**An Bord Pleanála Oral Hearing**

**Irish Water**

**Greater Dublin Drainage**

**Response to Inspector's Questions**

**EIAR Figure 8.6: Calibration locations**

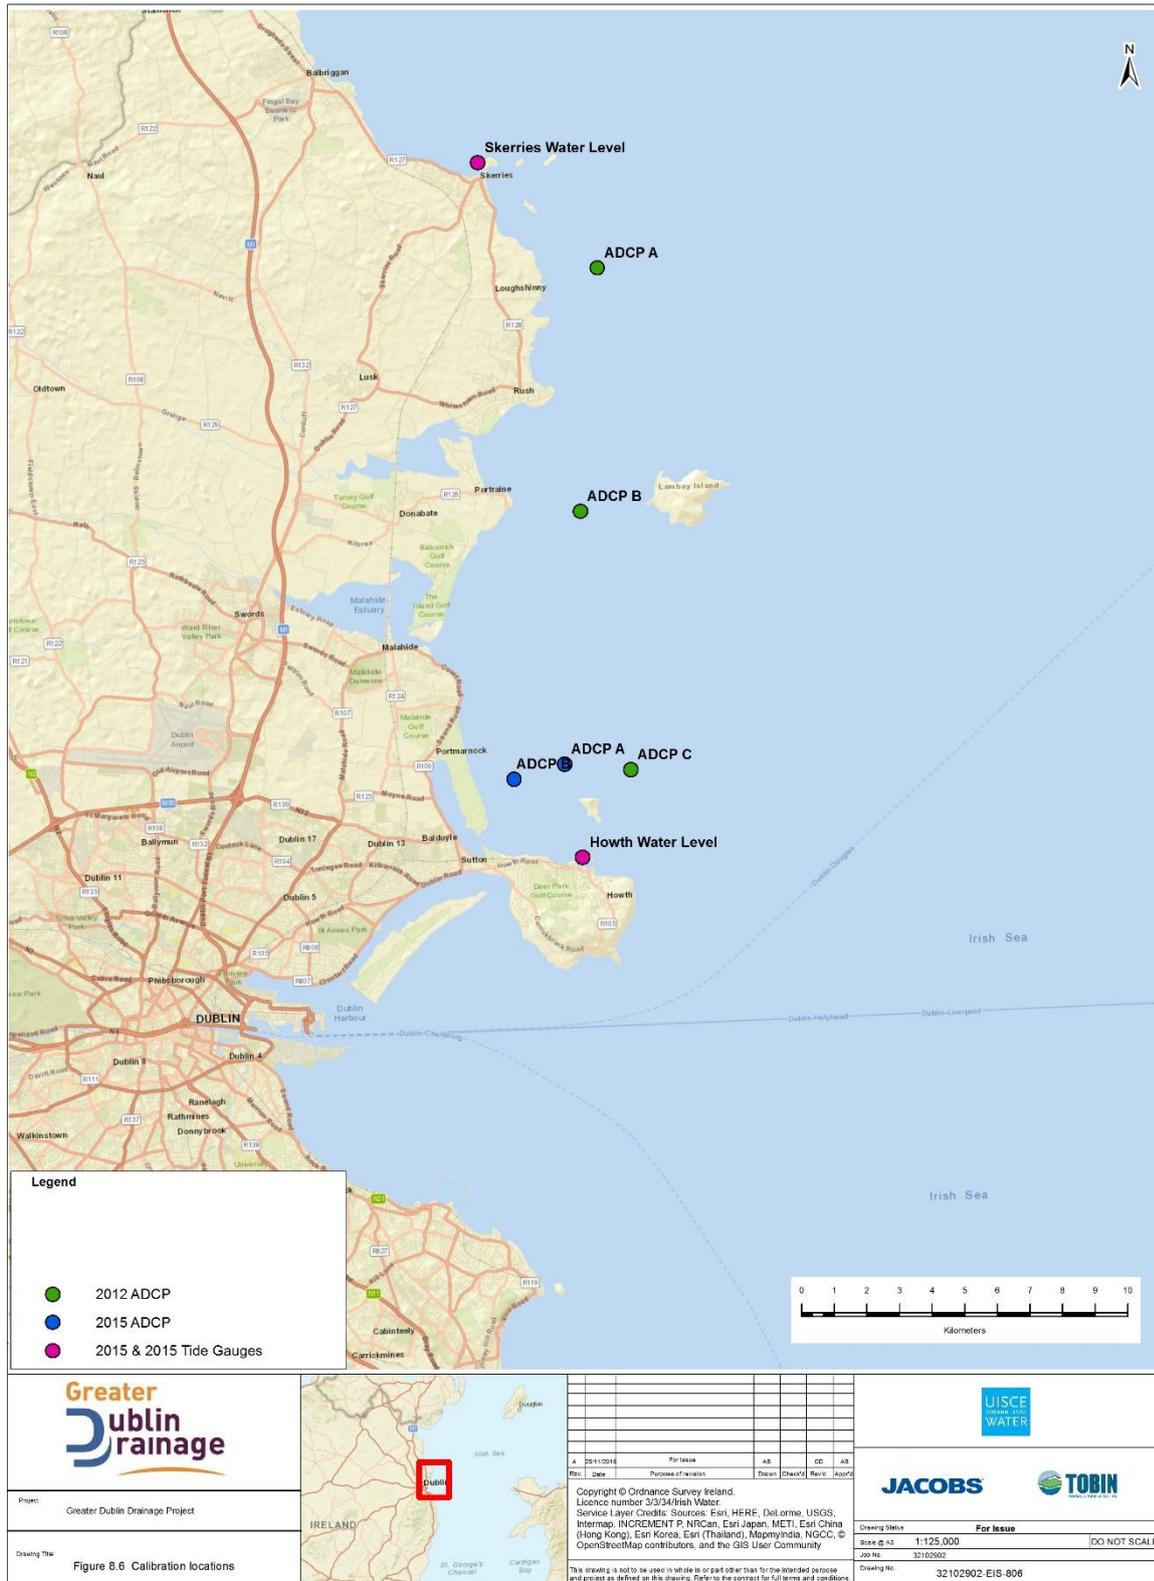
16 Could Mr. Berry address the issue of errors in modelling and what is meant by 'excellent' and 'good.'

32 Modelled tidal levels were compared against measured data at both the Skerries and Howth tide gauge locations in order to provide a quantitative assessment of inaccuracies in tidal characterisation.

- 33 Modelled current speeds and directions were compared against measured data at the ADCP locations A, B and C in order to provide a quantitative assessment of inaccuracies in tidal characterisation.
- 34 In order to quantify model calibration, a series of quantitative statistics have been calculated to compare water levels, current speeds and directions. The statistical assessment includes the derivation of the metrics listed above. The results are presented in Table 8.4 and Table 8.5 of the EIAR with **PASS** and **FAIL** of the above metrics highlighted where applicable.

- 36 In general, the comparison of the modelled and measured datasets, both statistically and visually, demonstrates a robust calibration agreement. Overall, Table 8.6 shows that the model is providing an 'excellent' representation of water levels and, generally, between a 'good' and 'reasonable' representation of current speeds and directions at the ADCP locations.
- 37 It is noted that the calibration of the model was 'good' at ADCP C location (the location of the proposed GDD marine outfall).
- 38 The summary of results presented above show that the numerical model has been successfully calibrated and validated against field measurements, to provide a sufficiently accurate representation of the hydrodynamics within the study region.
